CUY-90-14.90

**Conceptual Streetscape and Landscape Plans
(Contract Document)**

**Innerbelt Bridge
Construction Contract Group 1 (CCG1)**

5 - Addendum No. 5 - Various Document Updates
to sheets L0.2B, L1.2C, L2.3 and L3.2

Enlargement - Gateway
L2.3

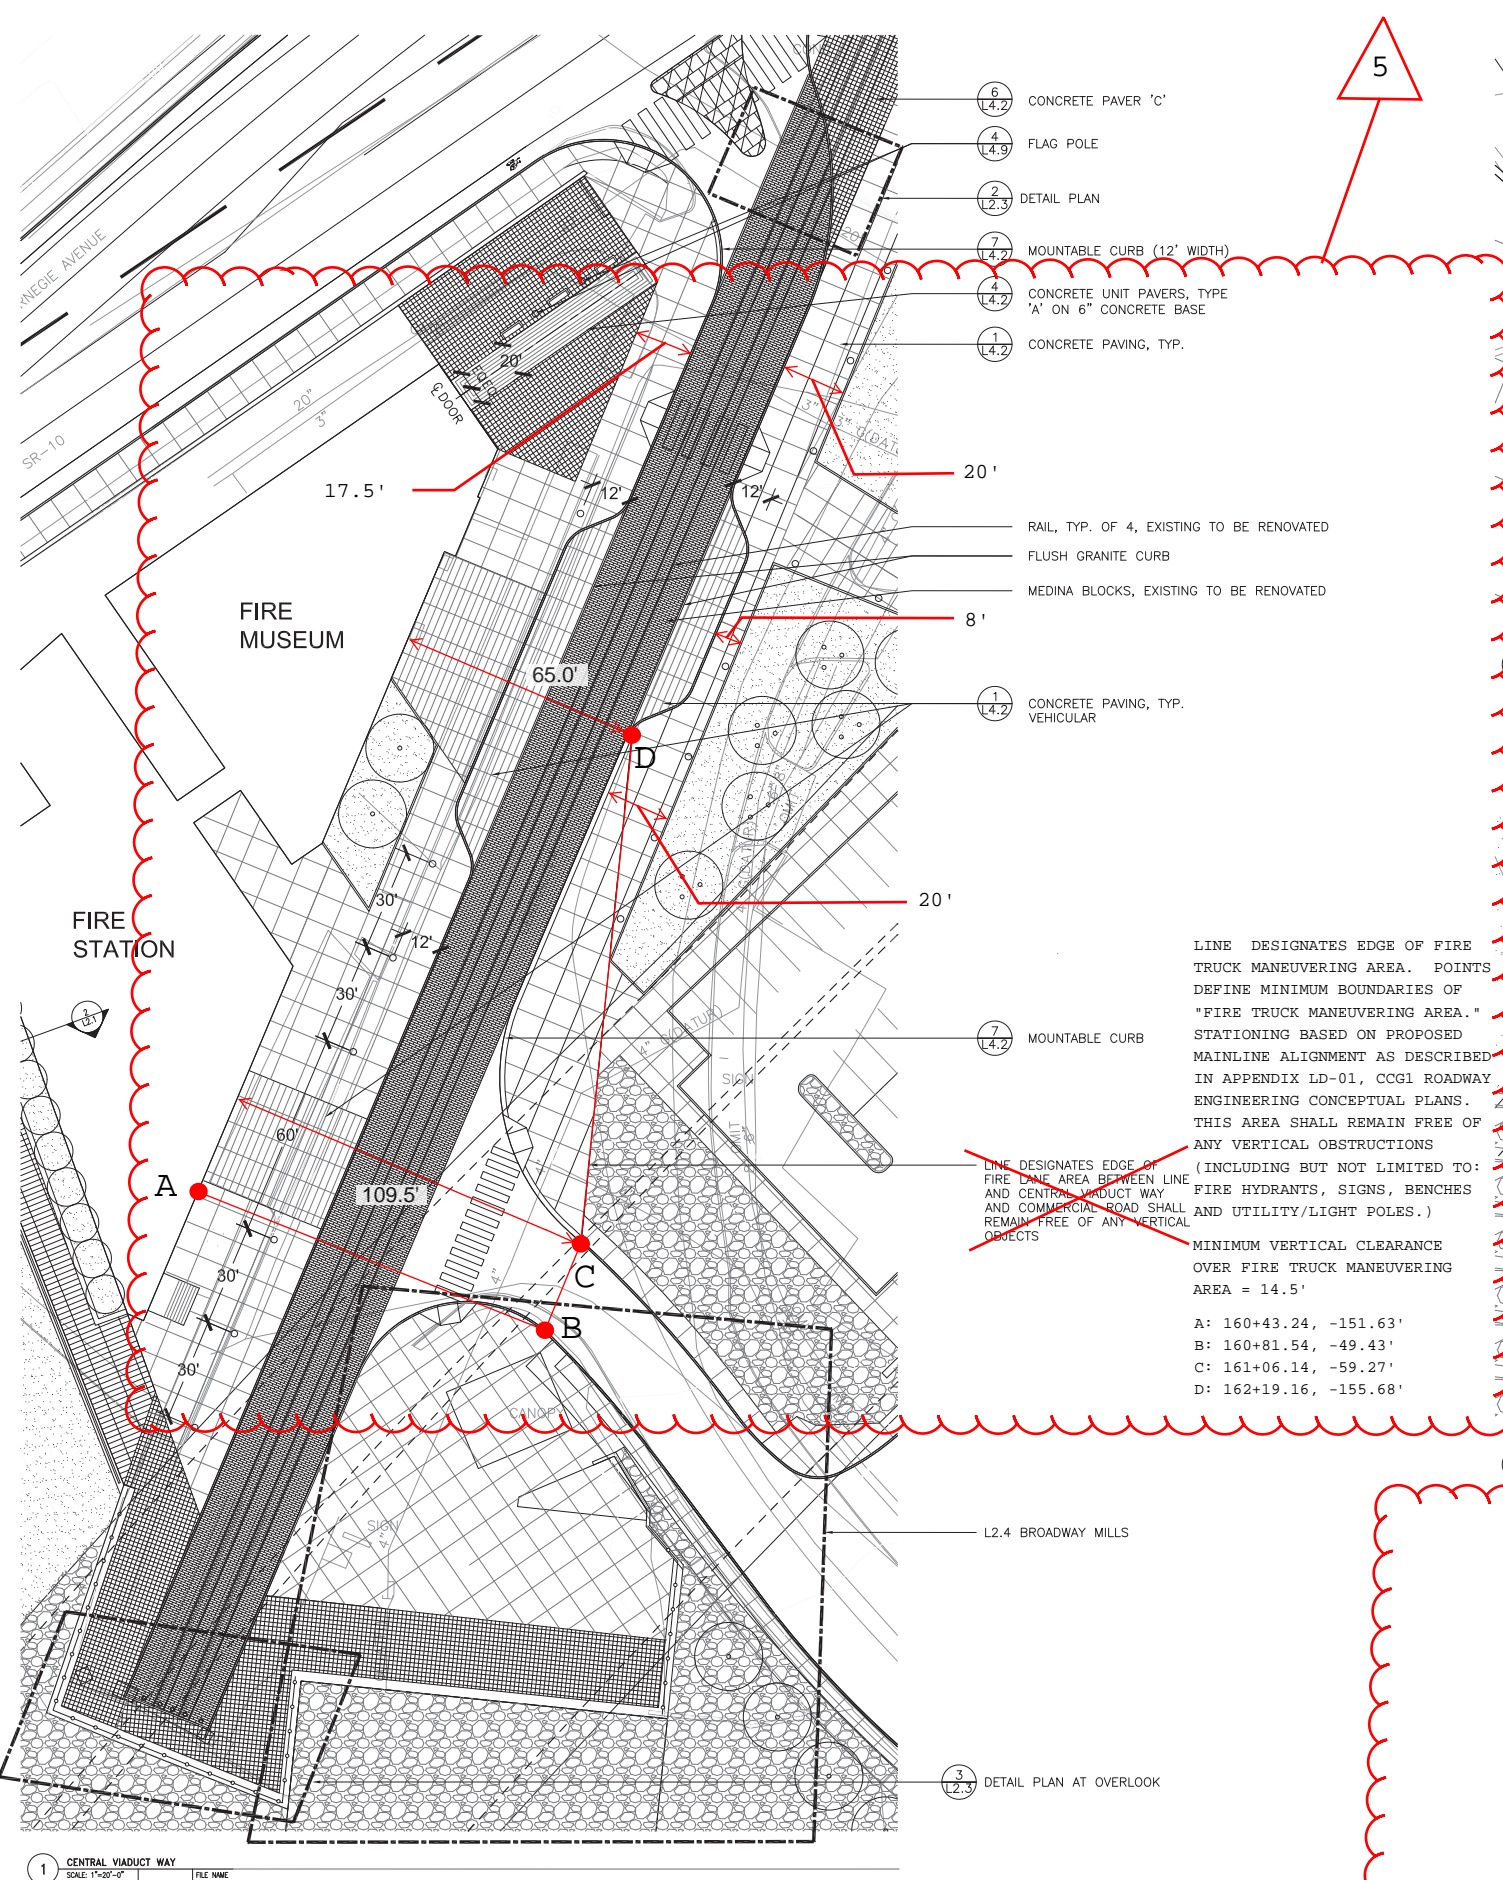
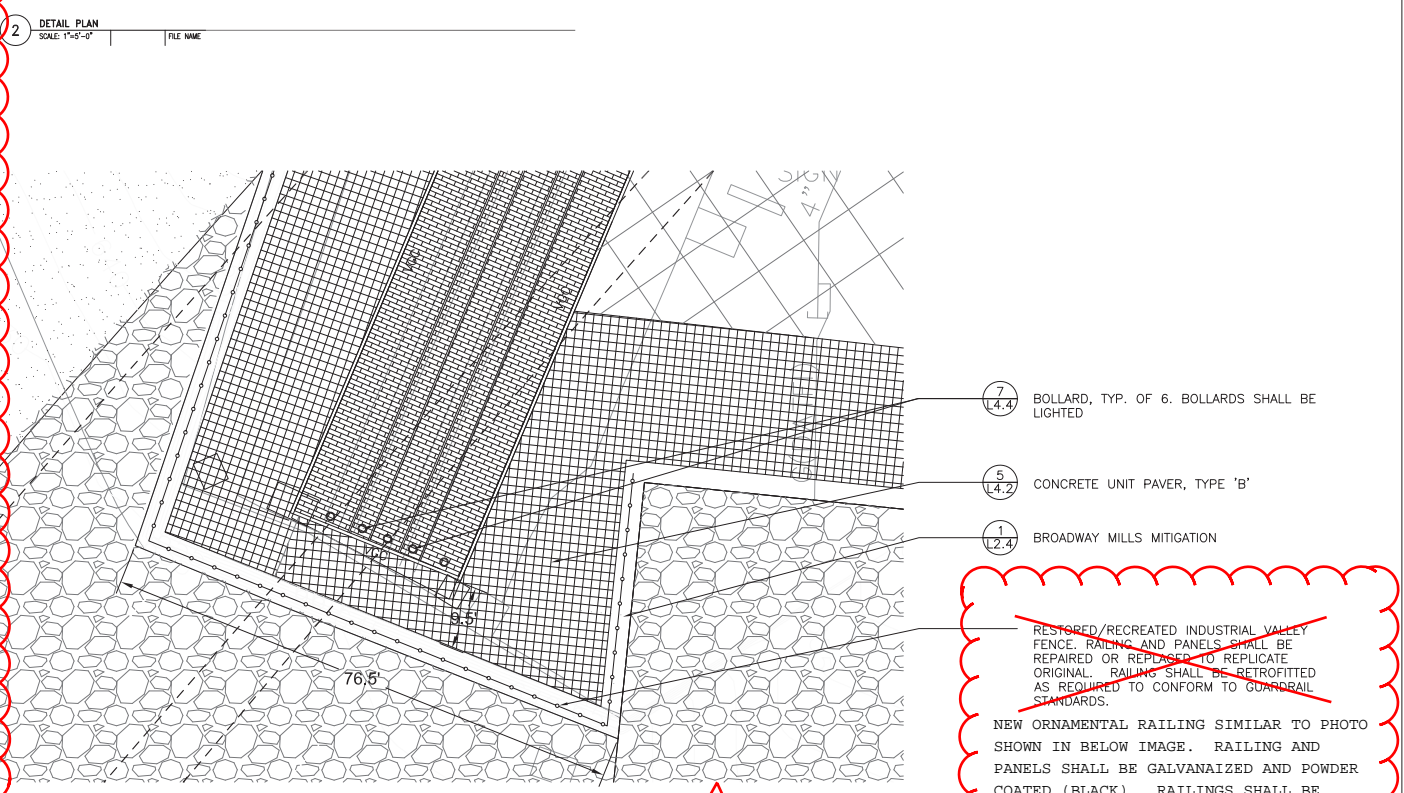
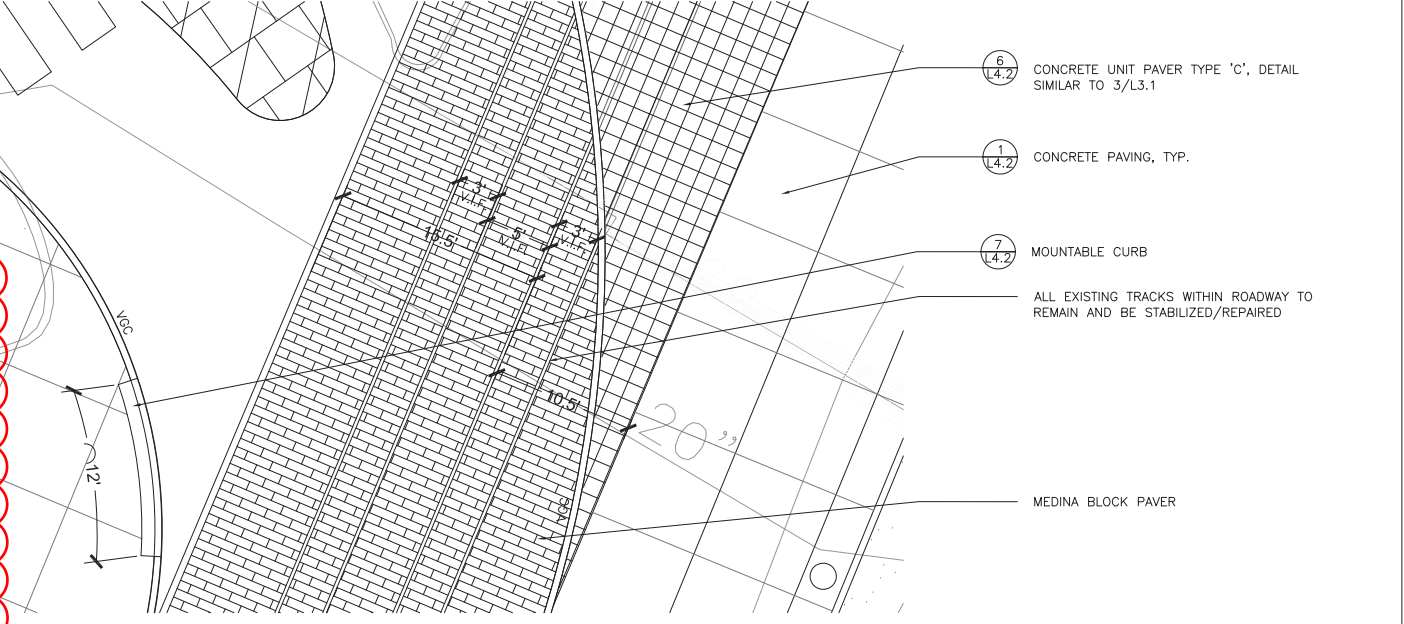
~~RESTORED/RECREATED INDUSTRIAL VALLEY FENCE. RAILING AND PANELS SHALL BE REPAIRED OR REPLACED TO REPLICATE ORIGINAL. RAILING SHALL BE RETROFITTED AS REQUIRED TO CONFORM TO GUARDRAIL STANDARDS.~~

NEW ORNAMENTAL RAILING SIMILAR TO PHOTO SHOWN IN BELOW IMAGE. RAILING AND PANELS SHALL BE GALVANIZED AND POWDER COATED (BLACK). RAILINGS SHALL BE RECTANGULAR/SQUARE TUBULAR STEEL.
